WILLIAMSON COUNTY, TEXASCHANGE ORDER NUMBER: 19

**FM3349 at US 79
Williamson County Project No. 22IFB139**

Change Order No. 19

Request for Information # 057

ILLUMINATION POLE BRACKET LOCATION AND REINFORCING

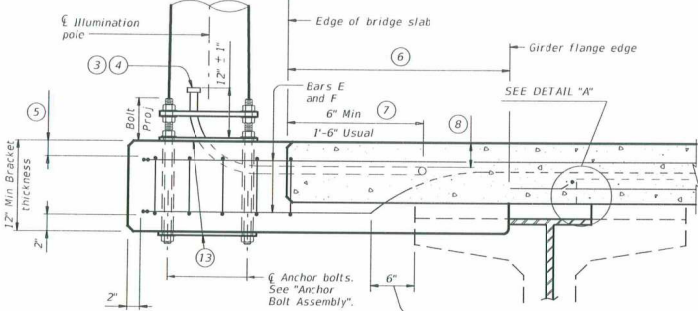
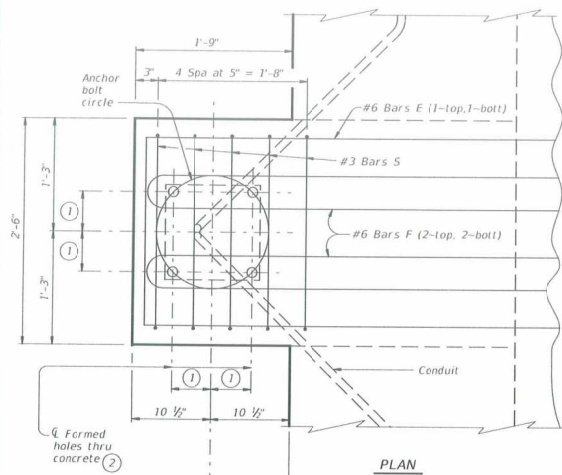
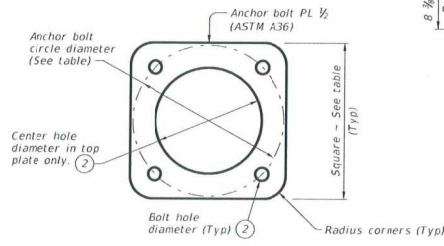
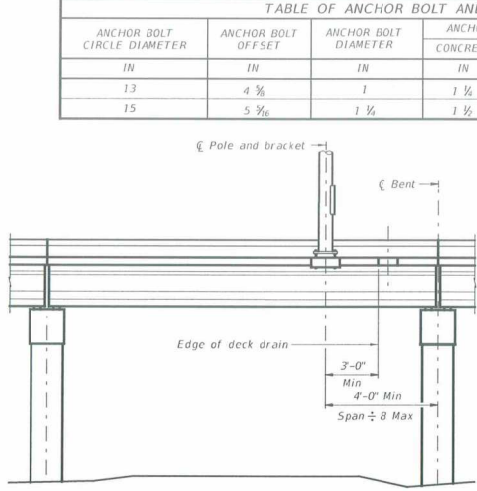
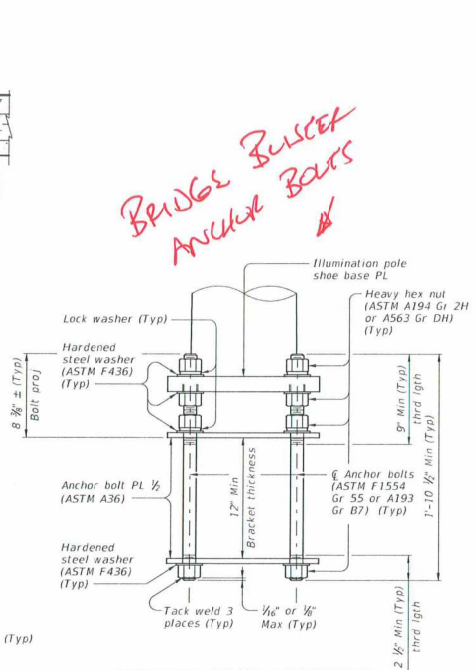
This Change Order compensates the Contractor for replacing the bridge blister anchor bolts for the illumination poles on the northbound and southbound bridges. The as-bid plan set specified the incorrect type of base plate and anchor bolts for the bridge mounted poles. The Contractor submitted an RFI proposing to use the specified base plates with the correct type of anchor bolts. The Engineer of Record (EOR) reviewed the request and agreed with the Contractor's proposal. As a result of this change, 27 previously approved and fabricated anchor bolt sets, will be replaced with the correct type for the specified illumination poles. The supplier did not give the Contractor the option to pay a re-stocking fee for the original anchor bolts. Therefore, 27 anchor bolts will be delivered to Wilco maintenance yard to be used in future projects.

RFI Detail:
I have noticed error in the bid item description for the illumination poles that need clarification: There is an error in the bid item description for the illumination poles. The 27 poles that are listed as "IN RD II (TY SA) 40S are "S" base poles, these are mounted on concrete foundations without a "T" base (mostly behind guard rail). The description should have read "IN RD IL (TY SA) 40B for bridge blister or retaining wall poles. See Below the 2 differences: 1. Anchor Bolts, the poles have a separate set of anchor bolts listed in the bridge details "BL". 2. Handhole height ATS mention that they don't see many blister poles with the correct handhole height, but we do need the correct anchor bolts (to attach the S base poles to the blister). Please let me know if the engineer is going to require the correct poles (B base), or will the correct anchor bolt with the S base poles be sufficient? We do have the S base poles materials on MOH.

IN RD IL (TY SA) 40S ("S" base) type poles have the same anchor bolt plate size, anchor bolt circle diameter size, and anchor bolt hole diameter size as IN RD IL (TY SA) 40B ("B" base) type poles required for bridge illumination pole brackets (BL standard) and retaining wall light pole brackets (RW-LB standard). Contractor to utilize the (27) IN RD IL (TY SA) 40S ("S" base) type poles the contractor already has MOH for all illumination poles mounted to bridge light pole brackets (BL standard) and retaining wall light pole brackets (RW-LB standard). BL and RW(LB) standards are located within the project plan set. Provide the correct anchor bolts only, per the BL bridge light bracket standards and RW(LB) retaining wall light bracket standards, for the (27) IN RD IL (TY SA) 40S ("S" base) type poles contractor already has MOH. GM@HDR.
